Local Planning Panel

Agenda

Item 3.**Development Application: 375-387 Cleveland Street, Redfern - D/2023/682**

Figure 38: Shadow diagrams

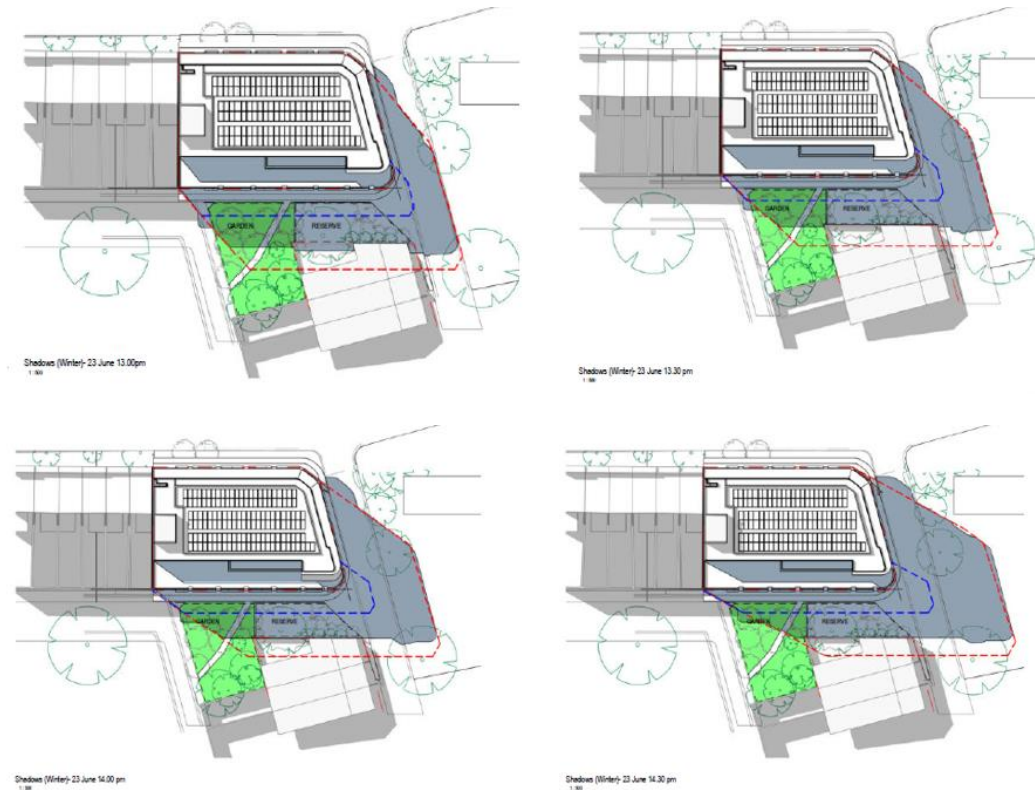
60. The overshadowing impact resulting from the proposed development, as amended (on 22 May 2024), is shown in the accompanying half hourly shadow diagrams reproduced below at Figure 38. The diagrams identify the existing shadows created by the existing car wash outlined in blue, the proposed development hatched in grey and shadows resulting from a 12m building envelope outlined in red. Half hourly sun eye diagrams are also provided at Attachment D.

61. The shadow diagrams demonstrate:
- Half of the northern garden is overshadowed by the existing car wash between 9.00am to 10.00am and a third is overshadowed between 10.00am to 12.00pm.

Figure 39: Original proposal dated 2 August 2023

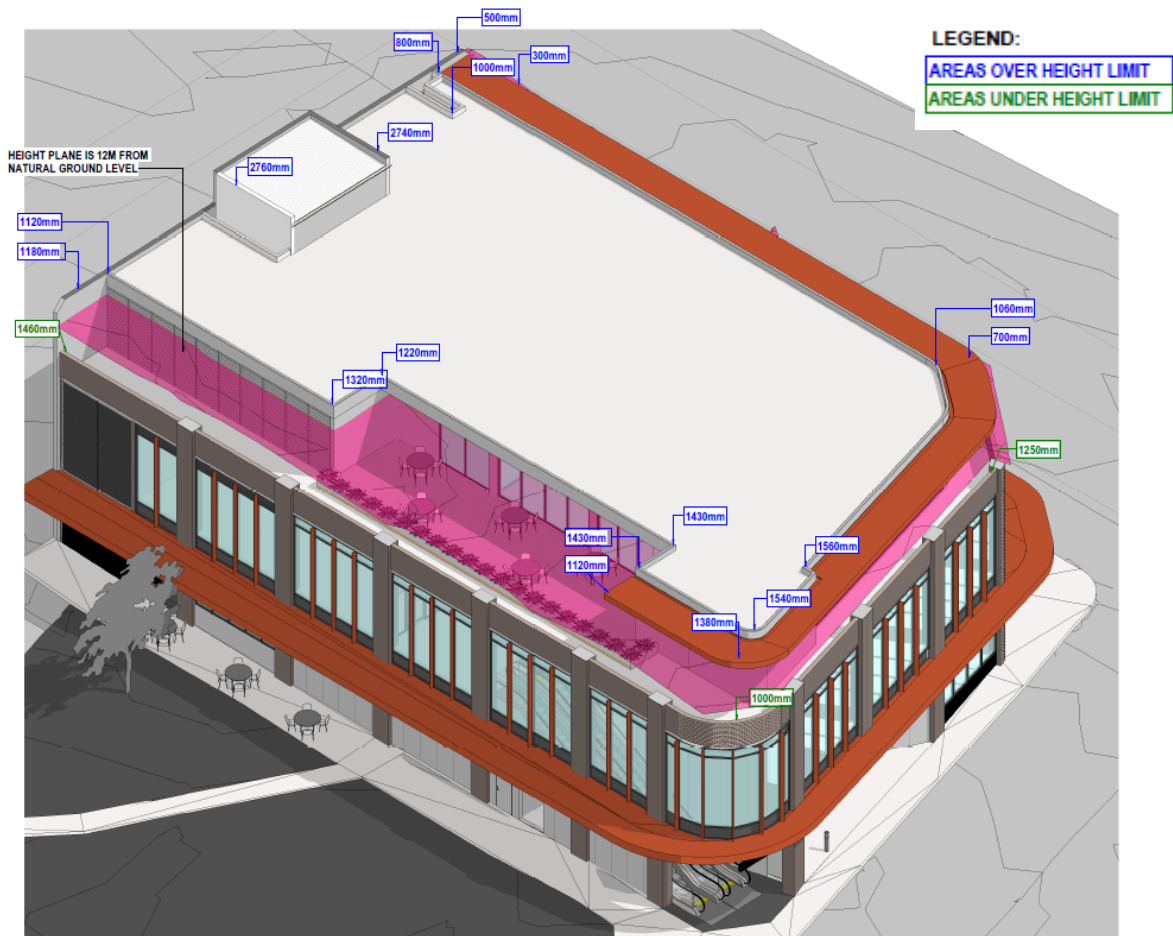
non-trafficable roof on the southern elevation, western blade wall at level 2, and the mechanical plant (refer to Figure 39).

64. The proposal has since been revised to reduce the building bulk at the south-west corner, reduce the level 1 floor to floor height by 0.3m (4.2m), and remove all of the above elements included in the original scheme (refer to Figure 42). The revised design provides an improved outcome compared to the original scheme, achieving sunlight to approximately half of the garden between 11.30am to 1.30pm.

Figure 42: Height plane drawing showing areas above the height control annotated in blue and elements below annotated in green

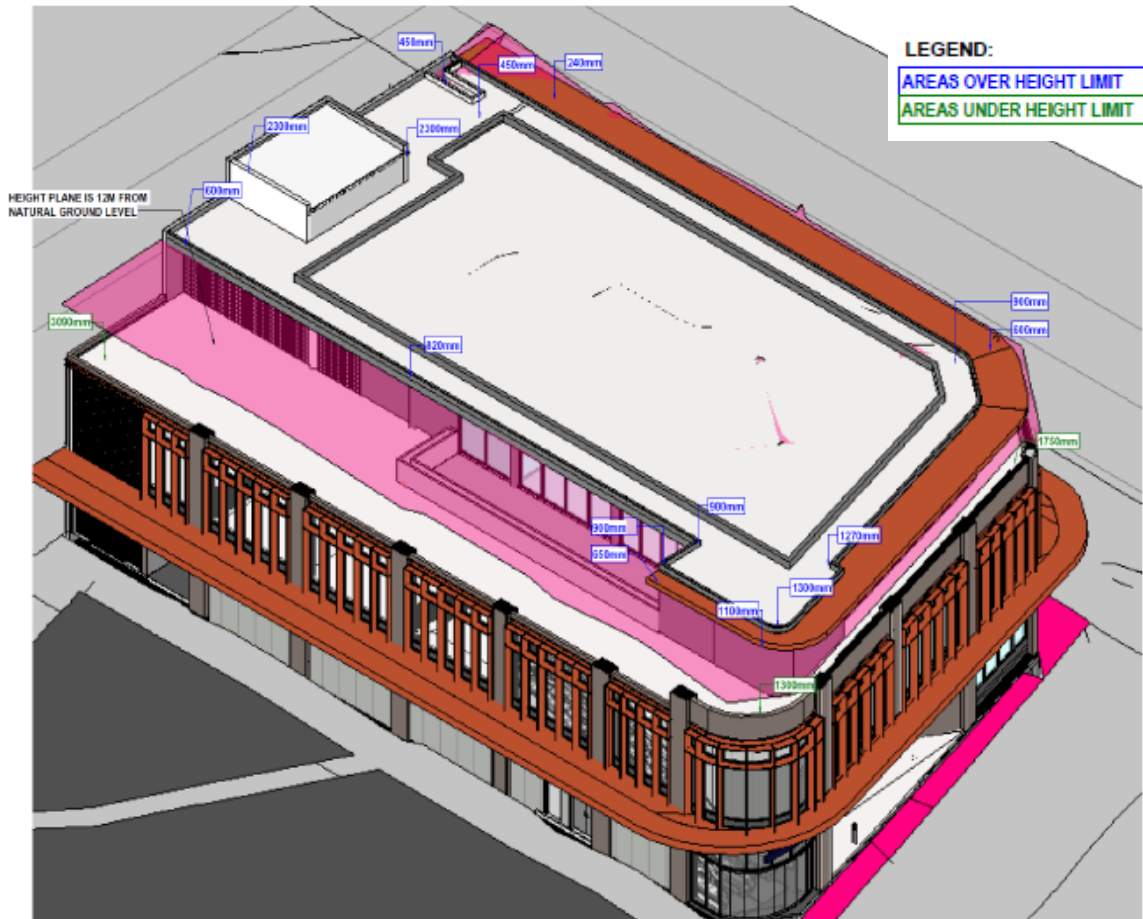
Provision	Compliance	Comment
4.3 Height of buildings	No	<p>A maximum building height of 12 metres is permitted.</p> <p>A height of 14.3 metres is proposed.</p> <p>The proposed development does not comply with the maximum height of buildings development standard.</p> <p>A request to vary the height of buildings development standard in accordance with Clause 4.6 has been submitted.</p> <p>Refer to further details and assessment provided in the 'Discussion' section below.</p>

67. A written request has been submitted to Council in accordance with Clause 4.6(3)(a) and (b) of the Sydney LEP 2012 seeking to justify the contravention of the development standard by demonstrating:
- That compliance with the development standard is unreasonable or unnecessary in the circumstances of the case;
 - That there are sufficient environmental planning grounds to justify contravening the standard;
 - The proposed development will be consistent with the objectives of the zone; and
 - The proposed development will be consistent with the objectives of the standard.

Image 01

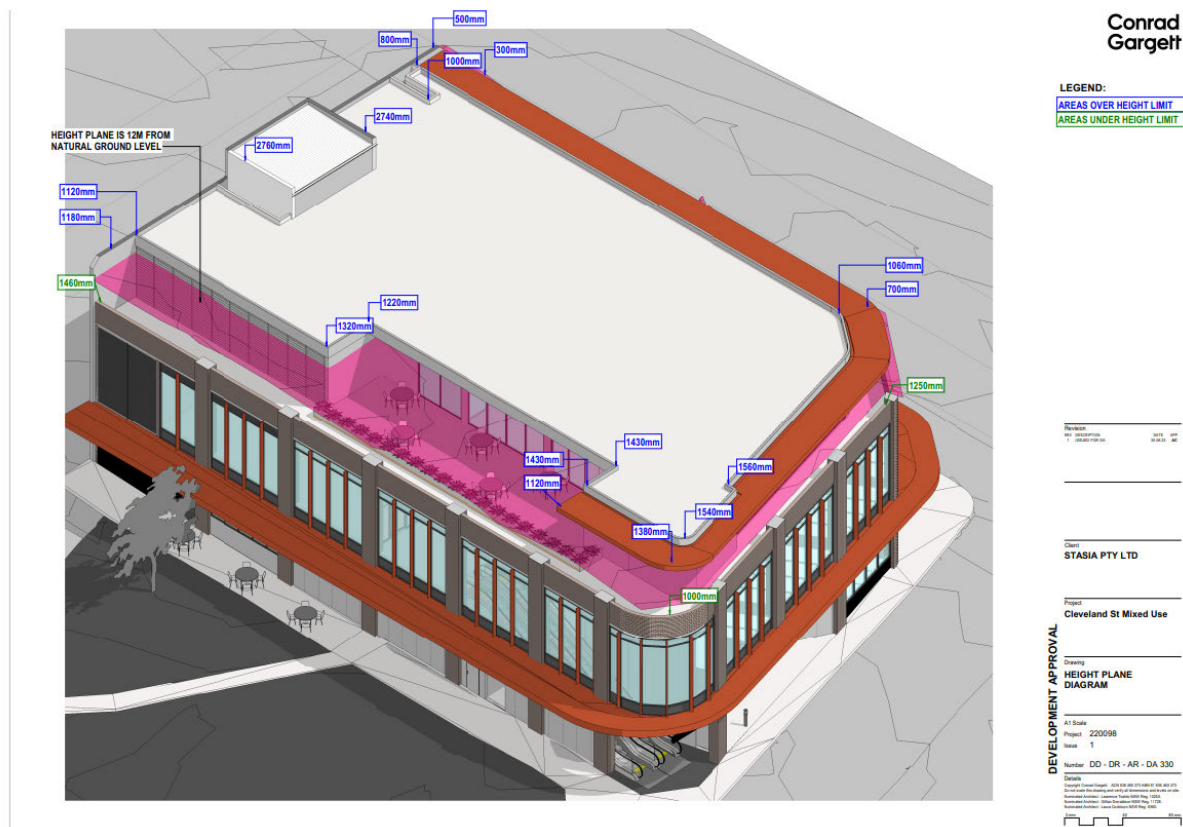
1. **Height Limit 12m LEP 2012** – the proposal at is highest is **2.76m over the height limit** (*image below extract from documents ‘Applications on exhibition’ – attachment Architectural Package – 375-387 Cleveland Street, Redfern_PAN_353939*)

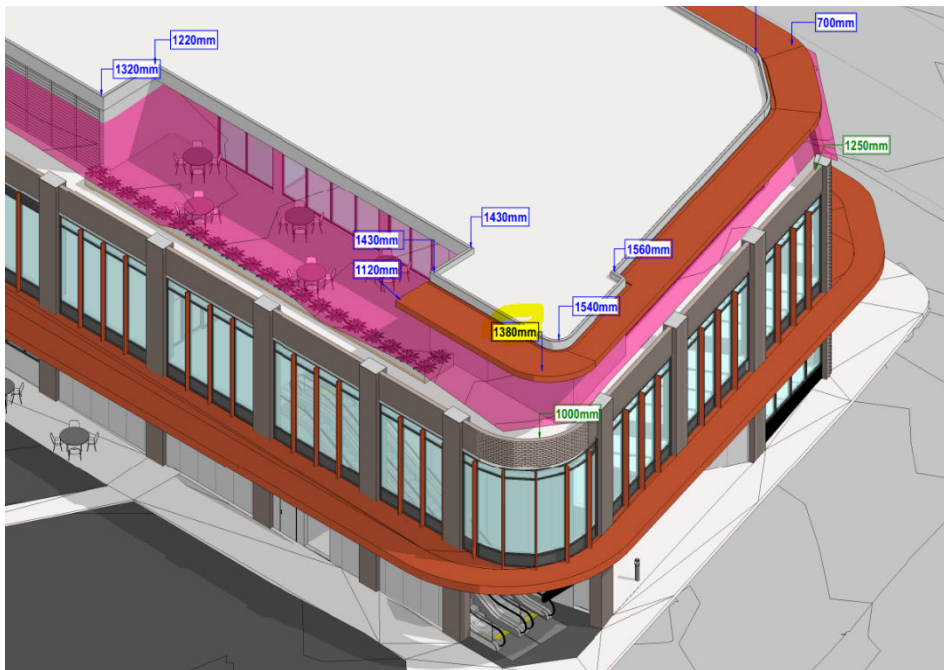
The above elevations listed show the LEP 12m Height Plane taken from the Ground Floor Level. This is completely wrong. As stated in the NSW Legislation Sydney Local Environmental Plan 2012 it is measured from the existing ground line in a vertical distance.

These elevations and sections are not correct. The East Elevation – Square Sheet 201 shows the 12m Height line taken from existing ground line. The Height Plane Diagram on Sheet 330 are misleading and incorrect as well, for example below image 04 indicates the awning is 1380mm above the height limit. But according to the East Elevation – Square (see Image 05 below) it is 1.7 over the height.
